Town Planning Committee Tuesday, 7 May 2024 at 6:30 PM

12.1	16 PIER STREET - NEW RESIDENCE	8
12.2	2 PARKER STREET - NEW RESIDENCE	53
12.3	83 DALGETY STREET - ALTERATIONS AND ADDITIONS	76
12.4	30 VIEW TERRACE - ALTERATIONS AND ADDITIONS - AMENDED PLANS	104

Owner	Kirk Tomlinson & Erin Bethel
Applicant	Averna Pty Ltd
Report Reference Number	TPR-1783
Planning Reference Code	P019/24
Prepared by	James Bannerman
Supervised by	Andrew Malone
Meeting date	Tuesday, 7 May 2024
Voting requirements	Simple majority
Documents tabled	Nil

Figure 1.1 Screenshot from Under Croft Plan showing rear access ending short of the street (Red Square).

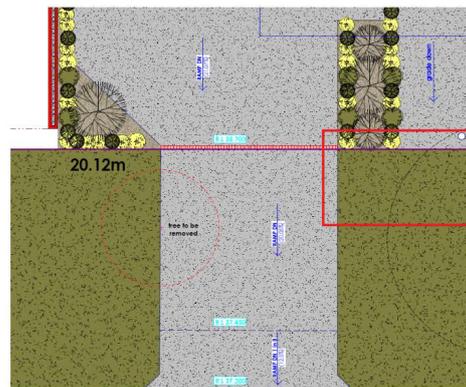
Further to the above, the provided plans do not clearly show how the rear access will be utilised as it does not connect to the street (**Figure 1.1**) although this is the current crossover to the property. Further information is required from the applicant to allow assessment of this aspect of the development application.

Further to the above, the provided plans do not clearly show how the rear access will be utilised as it does not connect to the street (Figure 1.1) although this is the current crossover to the property. Further information is required from the applicant to allow assessment of this aspect of the development application.

Figure 2.1 Over height portion of building shown in yellow

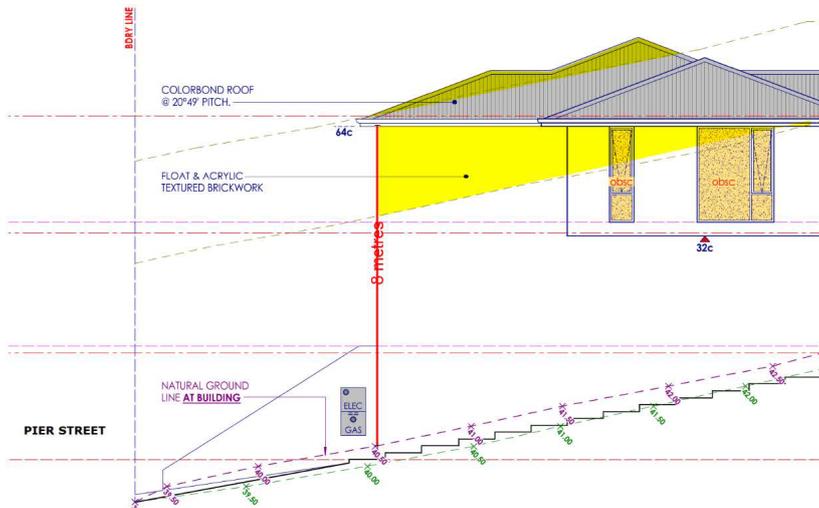
- The portions of building which exceed the required 5.6m wall and 8.1m roof height are highlighted in **Figure 2.1**. The extent of the over height wall and roof height will result in significant bulk and scale on the streetscape and will result in a significantly detrimental impact on the views from the adjoining property towards the river and ocean.

- *The portions of building which exceed the required 5.6m wall and 8.1m roof height are highlighted in Figure 2.1. The extent of the over height wall and roof height will result in significant bulk and scale on the streetscape and will result in a significantly detrimental impact on the views from the adjoining property towards the river and ocean.*

Figure 2.2 Figure 24 from the Local Planning Policy showing maximum 30% allowance for garage width

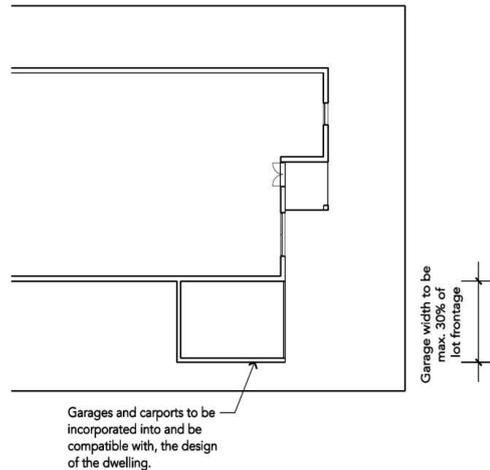
- *Figure 24 of the Local Planning Policy, which is reproduced below (Figure 2.2), specifies the garage width, for new dwellings, to be a maximum of 30% of the lot frontage. Lot 234 has a Lot frontage of 20,120mm, as shown on the Proposed Site Plan, giving a maximum garage width of 6,036mm. All though no measurements are shown on the provided drawings specifically for the garage width, it is estimated that it exceeds 8,380mm based on the combined width of the auto sectional doors, not including the pillar separating the two cross sectional doors.*

Given the above, the garage width significantly exceeds the maximum allowable and does not comply with this aspect of the Local Planning Policy.

Figure 24 of the Local Planning Policy, which is reproduced below (Figure 2.2), specifies the garage width, for new dwellings, to be a maximum of 30% of the lot frontage. Lot 234 has a Lot frontage of 20,120mm, as shown on the Proposed Site Plan, giving a maximum garage width of 6,036mm. All though no measurements are shown on the provided drawings specifically for the garage width, it is estimated that it exceeds 8,380mm based on the combined width of the auto sectional doors, not including the pillar separating the two cross sectional doors. Given the above, the garage width significantly exceeds the maximum allowable and does not comply with this aspect of the Local Planning Policy.
